Re: Jindera Solar Farm (SSD-9549) Request for Additional Information

As requested, please see a consolidated response to your request for information (dated 05/05/2020) below.
If you require further clarification, please don't hesitate to contact me by my details below.

Haulage Route - Map 1

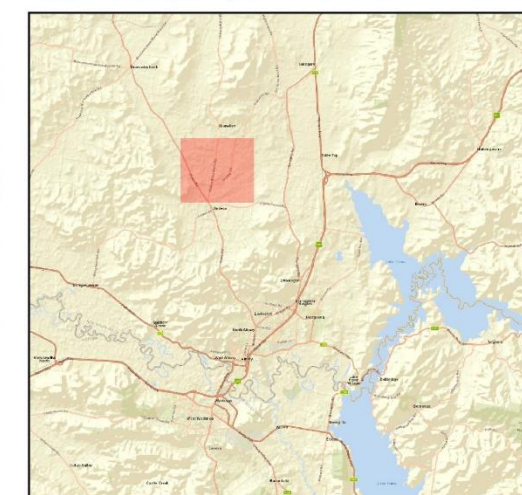
2	Confirm the haulage route from the State Road Network (Hume Highway) and provide a figure which identifies this route.	<p>As a minimum the following details are required:</p> <ul style="list-style-type: none"> Development footprint polygon. Transport route from the Hume Highway. The proposed Glenellen Solar Farm and where the haulage route is common for the two projects. Label all relevant roads, waterways, townships etc. 	<p>The proposed haulage route from the Hume Highway is as follows:</p> <ul style="list-style-type: none"> Thurgoona Road. Catherine Crescent. Dallinger Road. Union Road. Wagga Road. Urana Road. Jindera Walla Walla Road (as required). <p>All traffic will come from the south (northbound) to ensure no heavy vehicle traffic movements on Glenellen Road, or lesser unsealed roads to the north.</p>

<ul style="list-style-type: none"> Mark the road upgrades and site access points. 	<p>The above route was determined from the National Heavy Vehicle Regulator. The route planner is an interactive web-based tool which is continuously updated by (NHVR). The routes have been confirmed by use of the Transport for NSW Restricted Access Mapping tool, published by Transport for NSW. The routes have been modelled for 26m B-double routes and over-sized over-mass routes (OSOM).</p> <p>The Proponent is satisfied that the largest design traffic will be accommodated by the existing geometry of the proposed road network. It is likely that additional permits will be required for any OMOD vehicles entering the site via Urana Road, from its intersection with Hueske Road. Such permits can only, practically be obtained near the time of the proposed movements.</p> <p>The proposed haulage route has been inspected by the proponent including observations of the layout of junctions to ensure the full route is suitable for the proposed traffic, vehicle types and vehicle numbers.</p> <p>The haulage route is shown on the map at Appendix A.1 to this document and is also included as a separate document uploaded to the portal.</p> <ul style="list-style-type: none"> The development footprint of each of the intersections are included. The transport route from the Hume Highway is included. The development footprint of both the Jindera Solar Farm and Glenellen Solar Farm, and where the haulage route is common for both is included. All relevant roads, waterways, towns etc. labelled. All road upgrades and site access points are labelled.

Appendix A.3. Isolated finds map

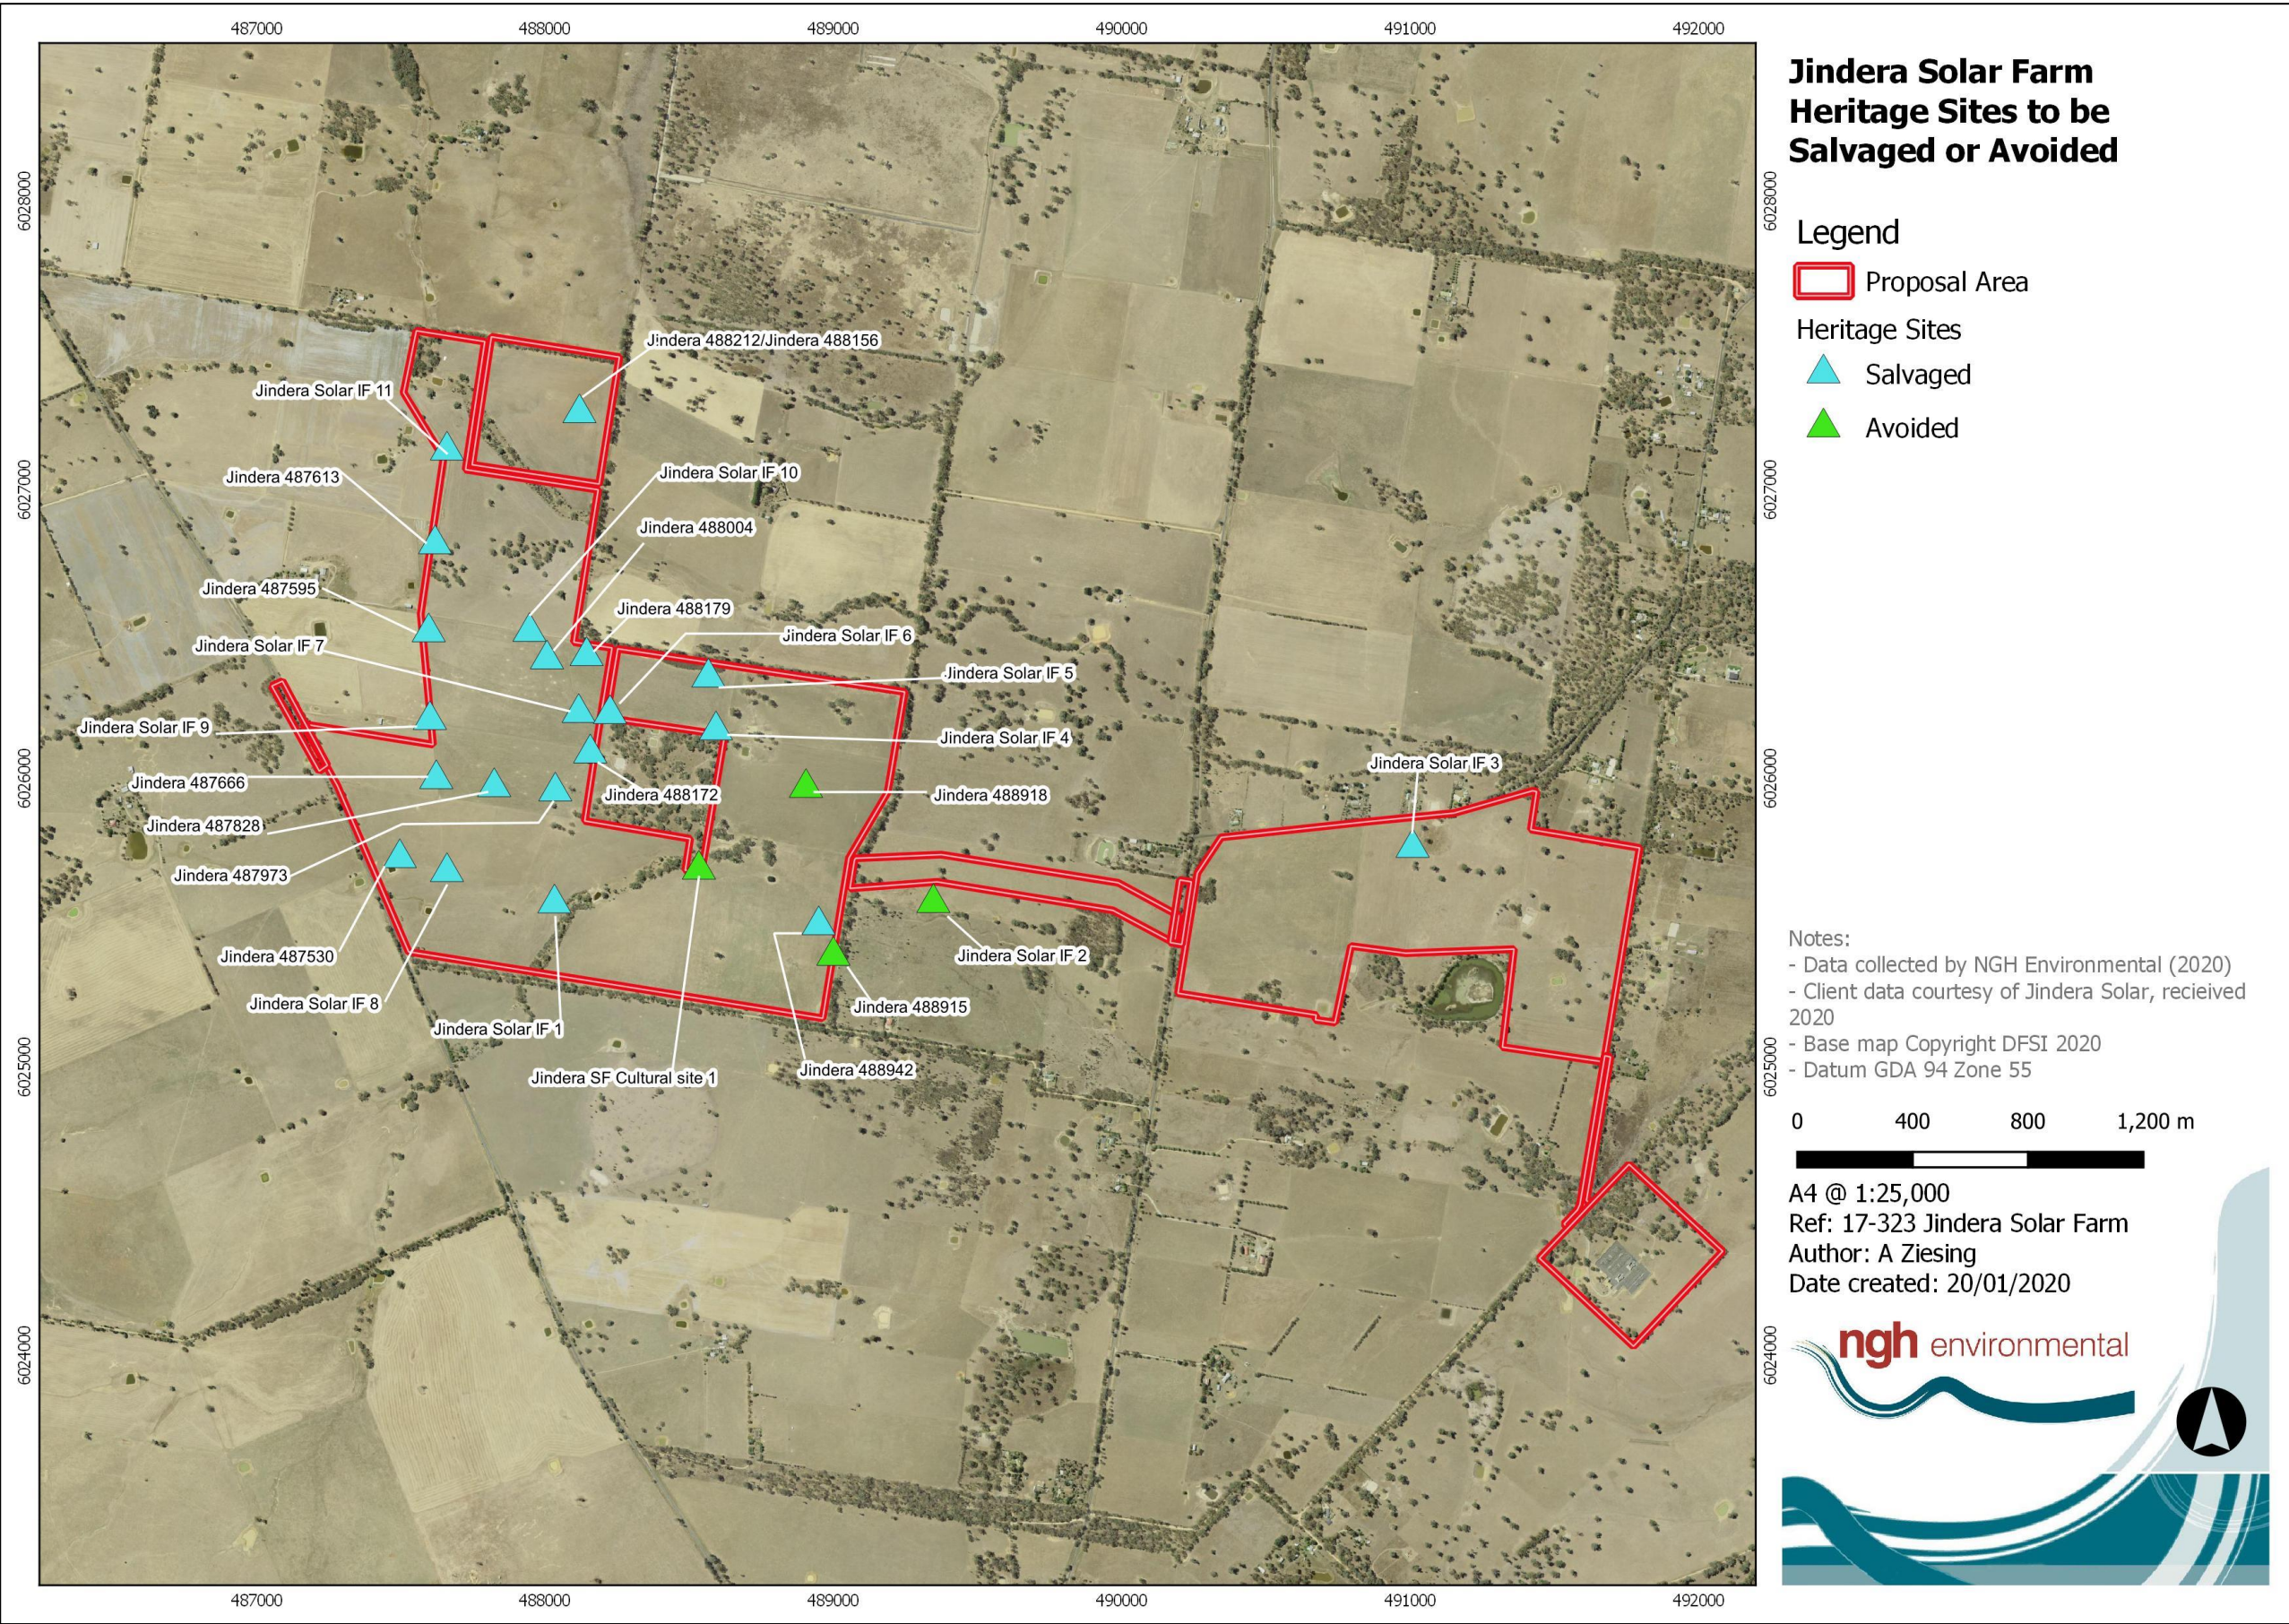
6	Heritage item figures.	<ul style="list-style-type: none"> • Revise figure 13 of the ACHAR to indicate whether items will be avoided, salvaged etc. 	<ul style="list-style-type: none"> • Figure 13 of the ACHAR has been revised. <p>See Appendix A.3 and separate attachment in the portal.</p>
Subdivision			
7	Subdivision requirements.	<ul style="list-style-type: none"> • Confirm that you do not seek to subdivide the land on which the onsite substation is to be located. • Provide a subdivision plan. 	<p>The Proponent is now required to subdivide for the substation.</p> <p>This has been addressed, and the subdivision plan provided, in the separate Amendment Direction (submitted 13/05/2020), which was requested DPIE on the portal on 07/05/2020.</p>
Main project layout			
8	Amendments required to the main project layout.	<ul style="list-style-type: none"> • Ensure panel array legend icon matches the map layer. • Add label for R18 on Glenellen Road. 	<ul style="list-style-type: none"> • The panel array legend item matches the map layer – it is simply a black transparent box. • The label for R18 has been included. <p>See Appendix A.4 and separate attachment in portal.</p>
